Service Bulletin FSN-30

Subject: NC-300 Changes

NC-300 REVISIONS

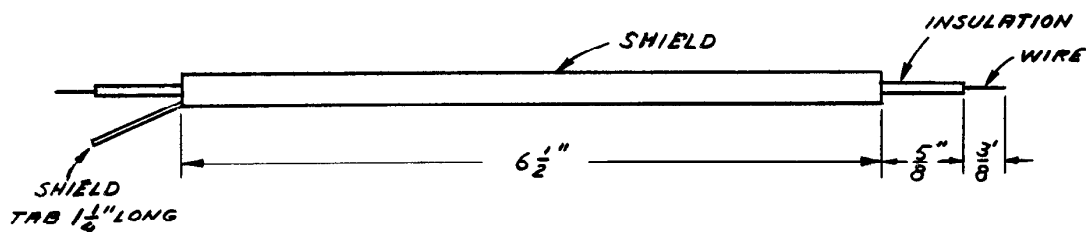
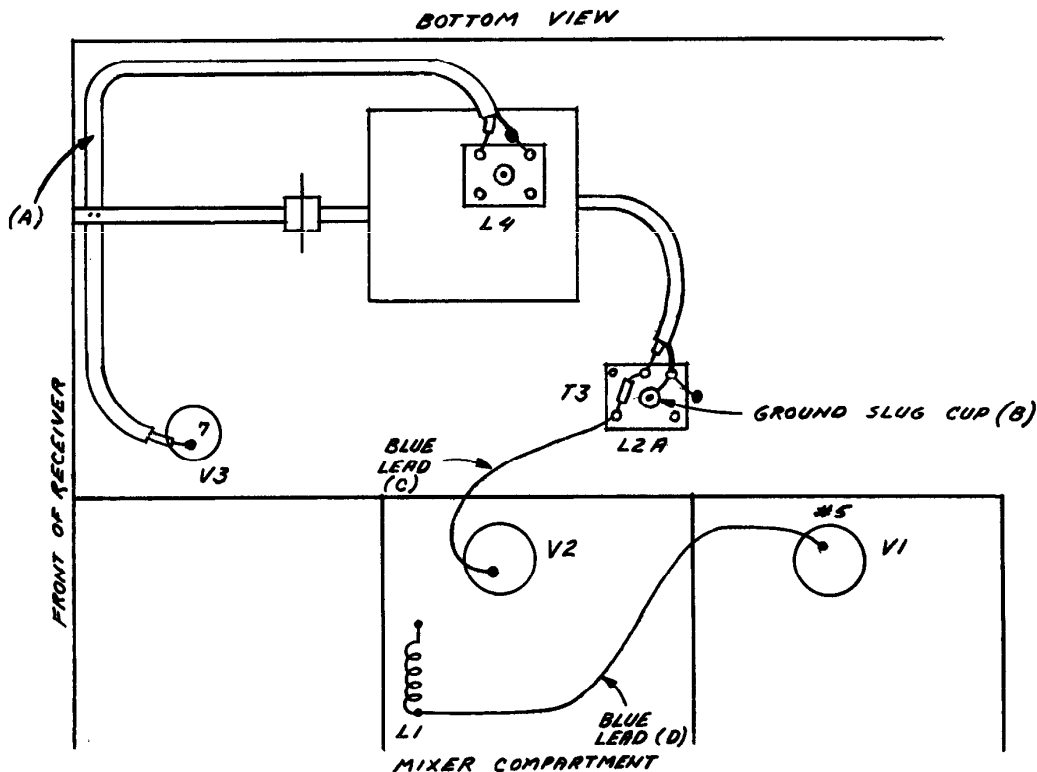
A considerable improvement in the response of the NC-300 receiver to this spurious frequency can be effected by the following modifications:

A shielded lead should be constructed as shown below:

- A. Replace shielded lead from L4 to grid of second converter, V3 with above lead, placing it under phasing control shaft as shown in the pictorial diagram below.

SUBJECT: NC-300 C6 Changes

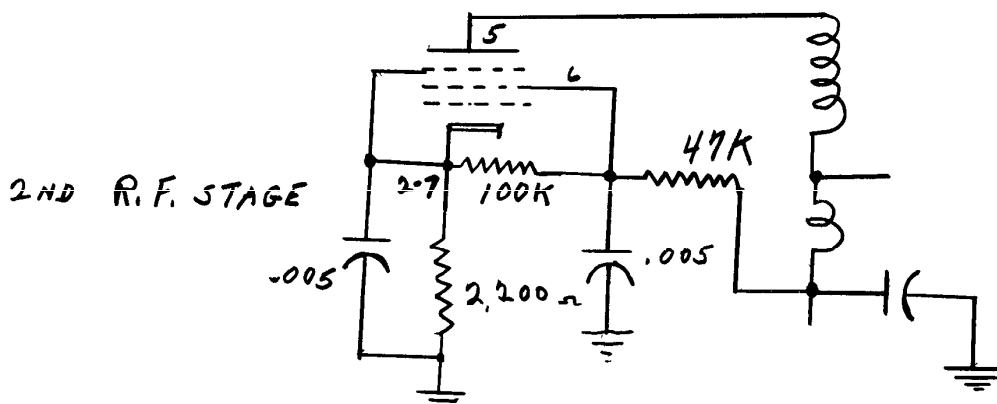
The following changes are recommended in the 6-meter converter to reduce cross-modulation:

Change cathode resistor in 6AK5 2nd R.F. amplifier stage from 470 ohms $\frac{1}{2}$ watt to 2200 ohms $\frac{1}{2}$ watt

A 100,000 ohm $\frac{1}{2}$ watt resistor should be connected between Pin #6 and Pin #2 - 7 of the same 6AK5 2nd R.F. stage

Revised circuit below:

Bulletin Number FSN-48

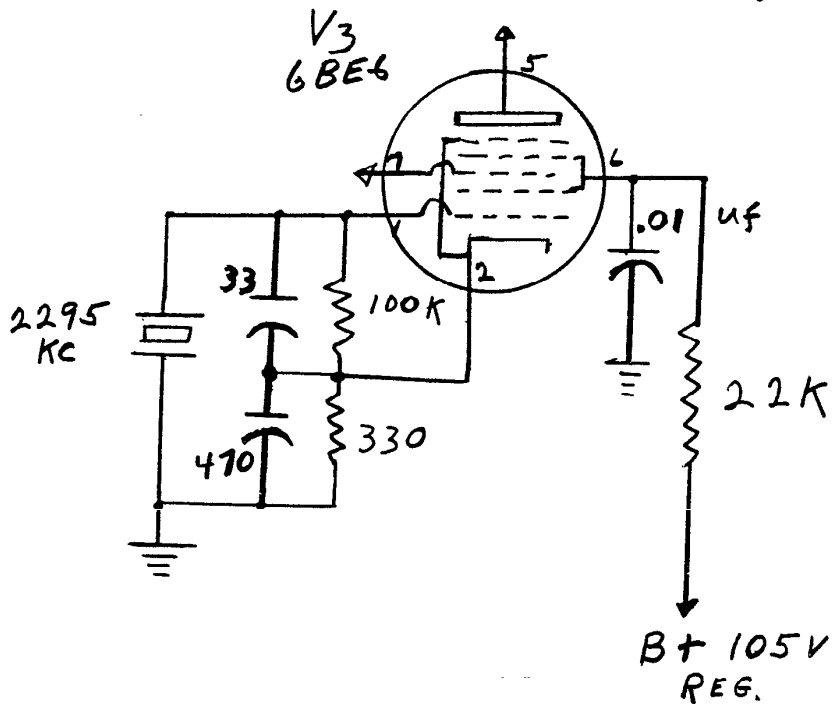
In these instances we recommend crystal control of the second conversion oscillator as per the attached schematic. It should be remembered that there are now two crystals in the circuit which must be properly coordinated if the receiver is to work at maximum efficiency. Normal production tolerances in the grinding of the crystals may allow a situation to exist where the difference in frequency of the crystal in the crystal filter (2215 kc) and the crystal in the second conversion oscillator (2295 kc) is not exactly 80 kc (second IF).

Fig. 1—Crystal controlled second converter.

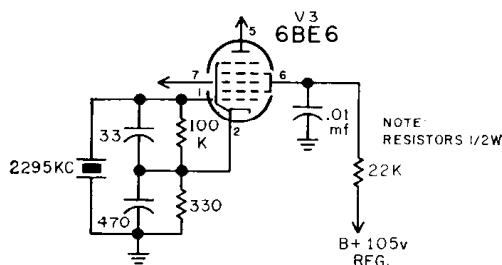
It is a simple matter to crystal control the second converter oscillator which effectively eliminates these problems.

The crystal and its associated components may be mounted in the shield can which formerly housed L6 the second conversion oscillator coil.

Fig. 2—Two new components improves audio.

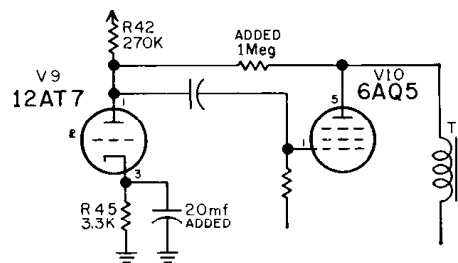
An audio change that will improve the phone quality is shown in fig. 2. It consists of a 1 megohm resistor connected between the plate of the output tube and the plate of the preceding audio stage. This has a tendency to drop the audio level which can be restored by bypassing the cathode of V9, R45 with a 20 mf, 50 volt capacitor to chassis ground.
